Date: October 16, 2012 Classification: General

**Notification of D200 Chassis design update**

**NOTICE**

Figure 4: New chassis, rear view

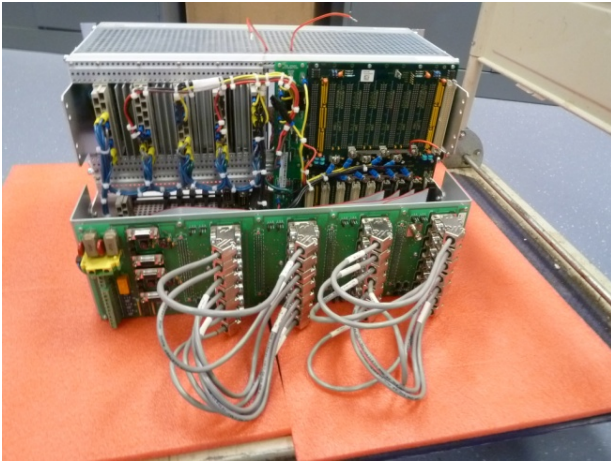
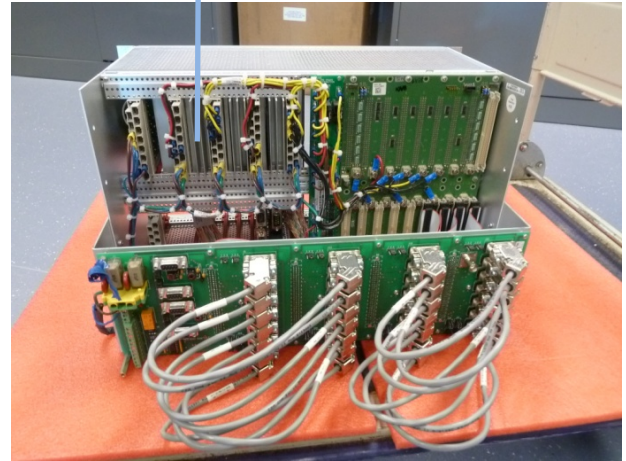
Upgrade from "through hole" to "surface mount" componentry for increased reliability

Figure 8: New chassis, power distribution (prototype)

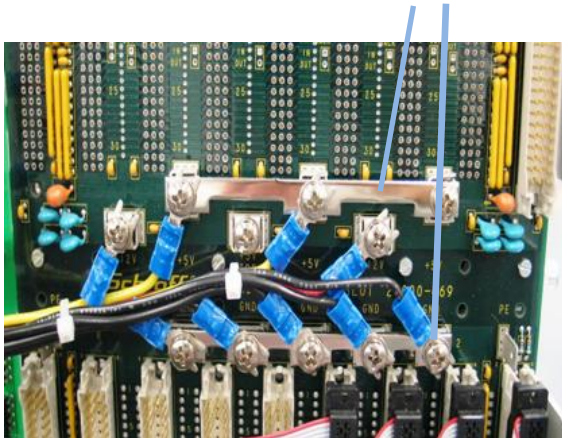
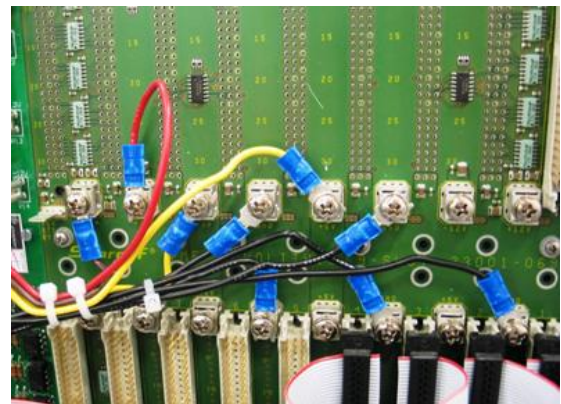
Power distribution connections implemented through external connections are now built into printed circuit board design for simplified assembly and increased reliability

Figure 9: Existing chassis, insertion rails

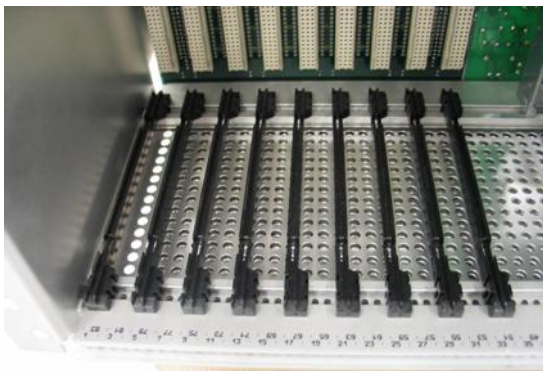
New insertion rails with grounding option for future enhancements

Figure 11: Existing chassis, serial panel mounting

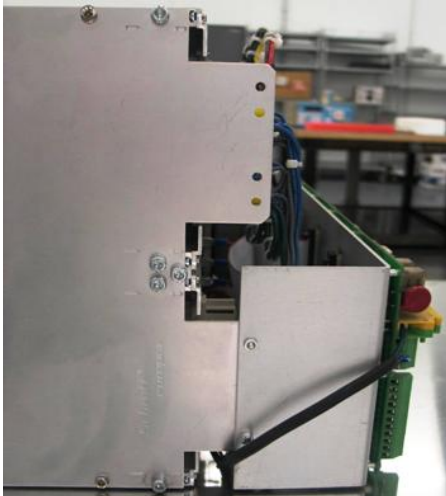
More space between D200 Chassis and backplane for ease of maintenance
